LOCAL HISTORIC DISTRICT: Plaza Midwood

PROPERTY ADDRESS: 1927 The Plaza

SUMMARY OF REQUEST: Front porch columns and handrails

Charlotte Historic District Commission Case 2017-744
HISTORIC DISTRICT: PLAZA MIDWOOD
FRONT PORCH CHANGES

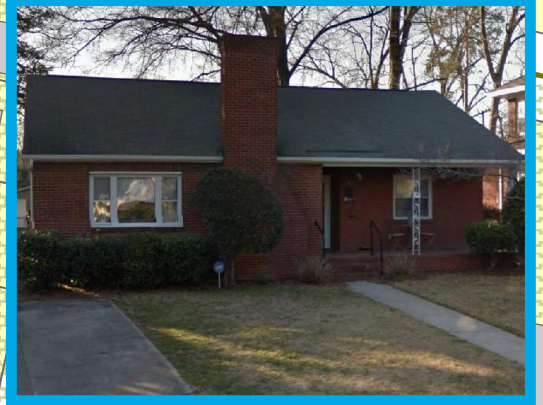
The existing structure is a one story ranch style home constructed in 1950. The front setback is 37'. Original porch supports were metal. A Notice of Violation was issued for work completed without a COA.

The project is the replacement of the metal porch supports with squared wood columns, one centered and on the right corner. Column dimensions are 9" x 7". The handrails are an administrative review and will be corrected to meet the guidelines.

The Commission will determine if the project meets the guidelines for porches.
